# **Demonstration of Surfactant-Enhanced Aquifer Remediation of Chlorinated Solvent DNAPL at Operable Unit 2, Hill AFB, Utah**

SUBJECT: HILL AFB SURFACTANT FLOOD DOCUMENTS

Subject: Technical Review of the DNAPL Tracer Tests at Air Force Plant 4,  
Fort Worth, Texas

Figure 3-2

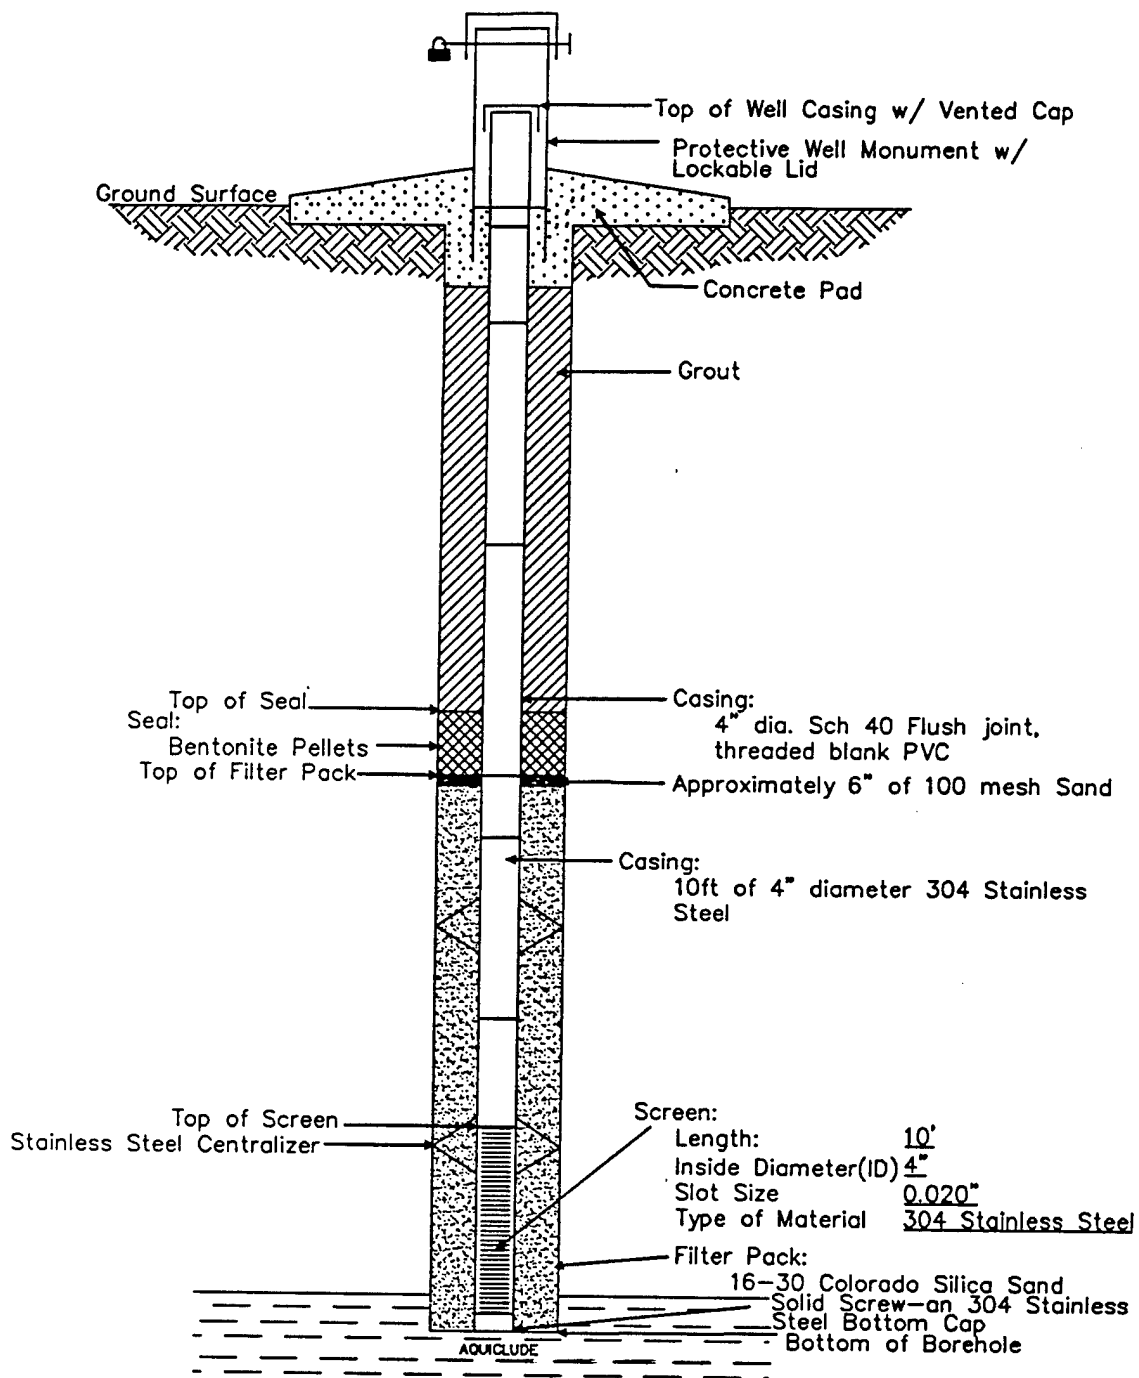
Item	Page	Section/ Paragraph	Line	Comment	Response/Action
1	3-8	Figure 3-2	NA	Correct this figure to show that the stainless steel casing was used for the first ten feet above the well casing.	The figure has been corrected and is attached for review.
2	3-21	Figure 3-7	NA	The labels for the test wells are difficult to read. Provide clear labels for the wells to orient the reader.	The figure has been revised and is attached for review. The well labels have been changed and the shading has been removed to make them more legible. A north arrow and axis labels have been added to orient the reader. The page size has been increased to an 11x17 format.
3	3-28	4	3	The second sentence in this paragraph is duplicated. Correct the text.	The duplicate sentence has been removed.
4	3-29	2	3	Provide a complete reference for Mariner et al., 1997.	The list of references has been updated to include Mariner et al, 1997. The revised Section 10.0 is attached for your review.

Figure 7-9

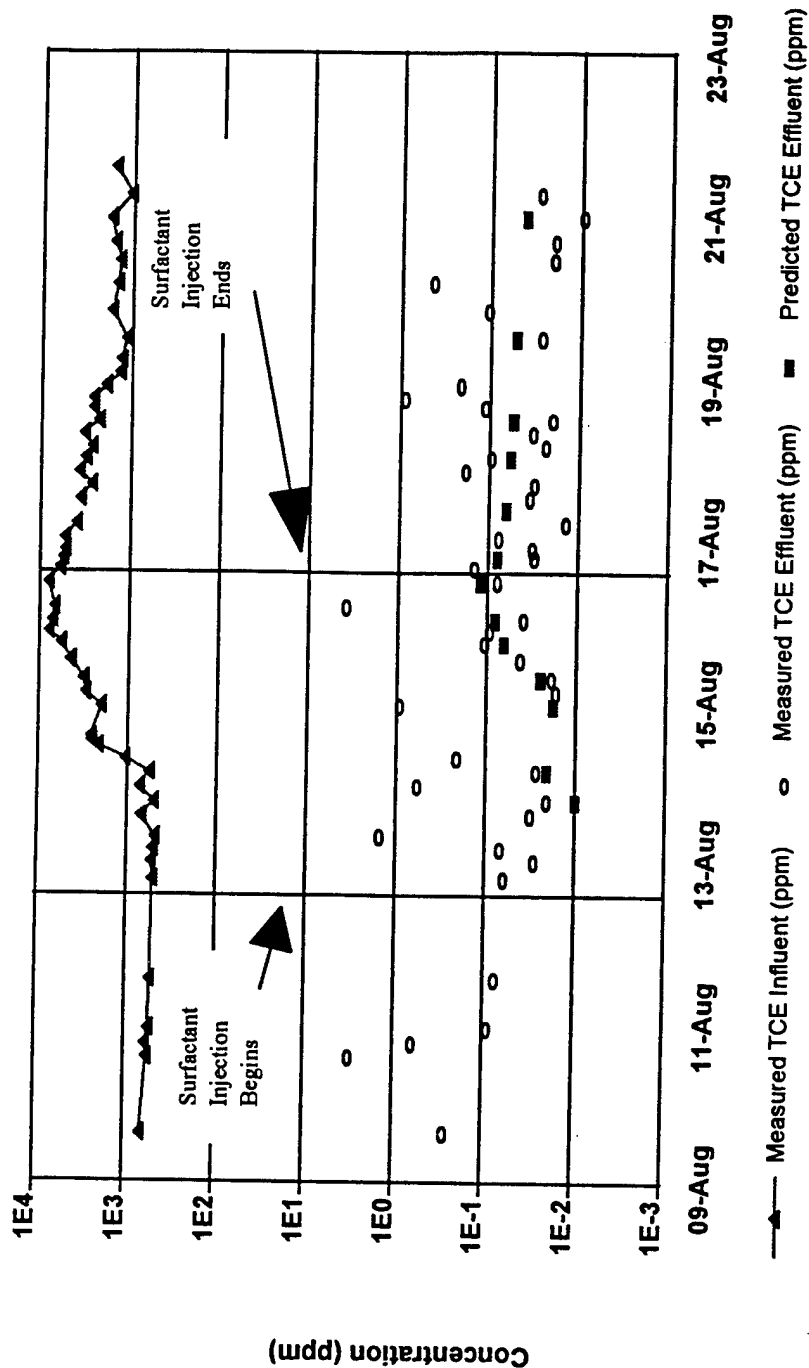
30	7-17	4	7	The phrase "to the stripper" is duplicated in this sentence. Correct the text.	The duplicated phrase has been removed from the sentence.
31	7-21	Figure 7-9	NA	No data are provided for isopropyl alcohol concentration, and the symbol is not shown in the legend. Provide the data, and correct the legend.	The graph and legend have been corrected to include isopropyl alcohol. The revised figure is attached for review.
32	7-22	2	4	The text states that baseline (no surfactant) conditions were modeled, but no results are presented. Modify the text to include the baseline modeling results.	The quoted statement is misleading. The sentence stating that baseline modeling had been conducted has been deleted.
33	7-23	Figure 7-10	NA	No data are provided for measured TCE effluent (parts per million), and the symbol is not shown in the legend. Provide the data, and correct the legend.	The graph and legend have been corrected to include measured TCE concentration. The revised figure is attached for review.

Figure 4-5\_\_—Comparison of Normalized Tritium and Surfactant Concentration During Surfactant Flooding in a Column

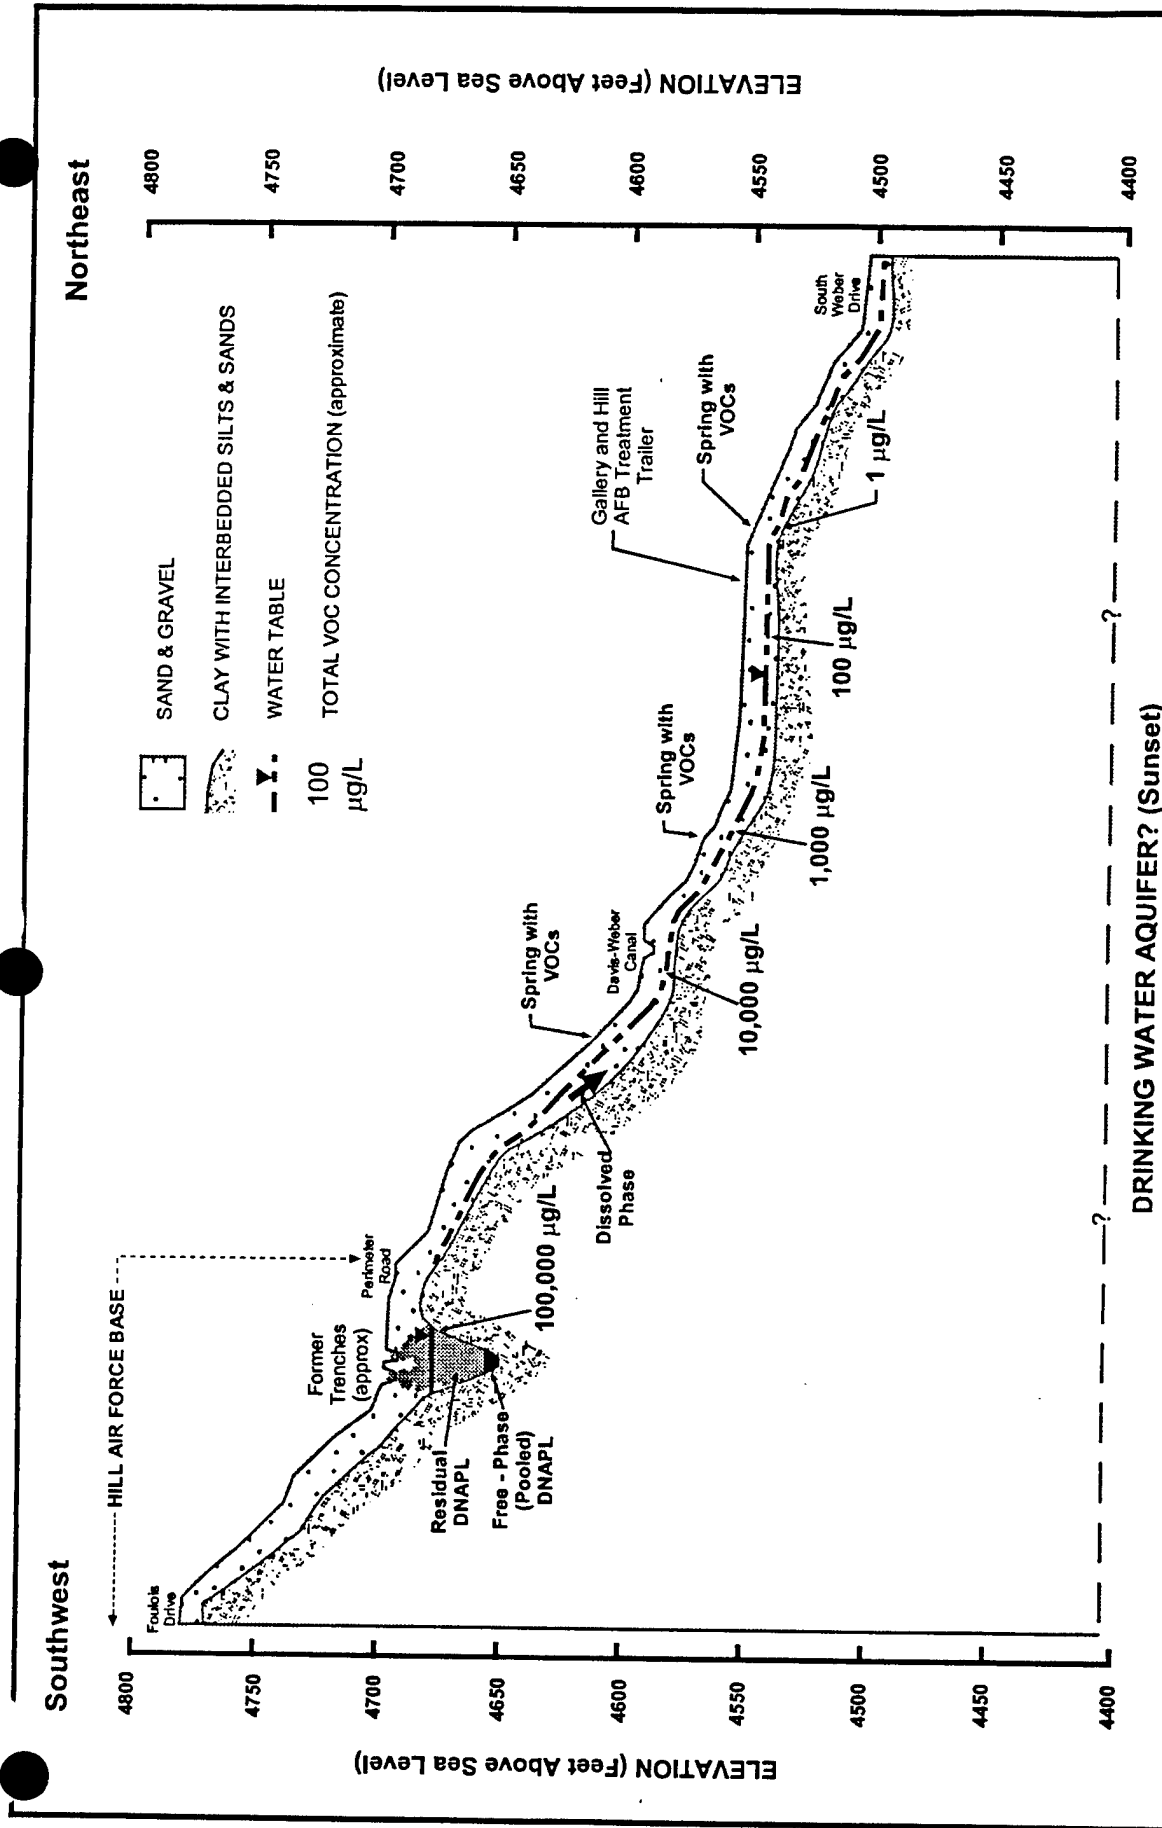
During our review of the document we noted that the scale shown in the legends of the Figures 4-3, 4-4, and 4-5 are labeled incorrectly. More significantly, we also noted that the well depths and positions of the screens are shown incorrectly in Figure 4-6. Based on the boring logs and land survey results, the bottoms of the screens all appear to be above the weathered shale and bedrock. DNAPL may have accumulated in thin layers in the shale below the elevation of the well screens and likely would not be fully contacted by the tracers.

DATE: 10/09/97	Generalized Cross-Section of OU2 (Modified from Radian, 1992.)	0 100 200 300 Feet Vertical Exaggeration: 4X
WID#: TAF 105 99999		
FILE: HILXSEC.XAR		
 © 1995 INTERA Engineering & Science Company	Hill AFB, Utah	Figure 2-6

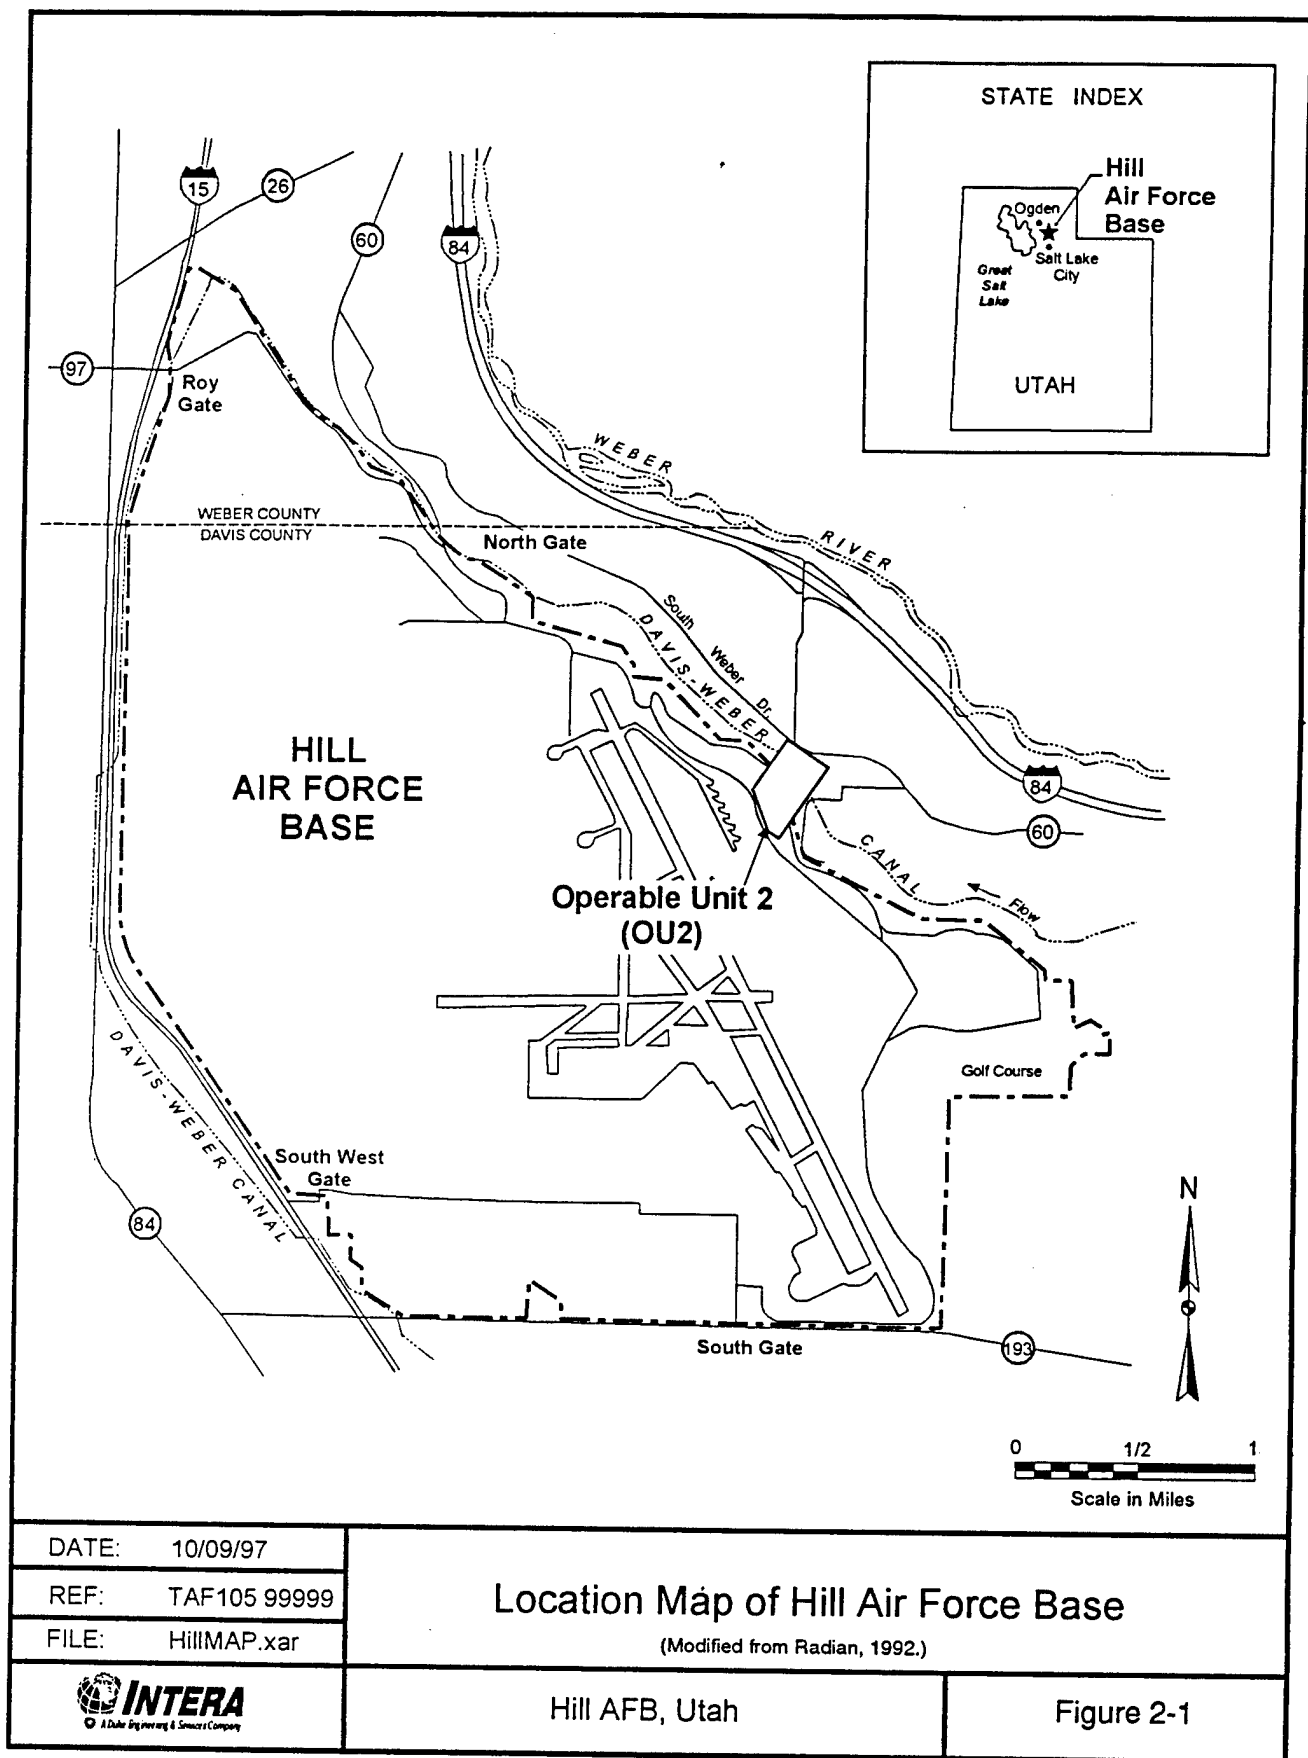
*Action/Revision:* This figure, now numbered as Figure 2-6, has been corrected to reflect the proper spelling of "Foulois Drive", and is attached for your review. The spelling of "Dissolved Phase" has also been corrected.
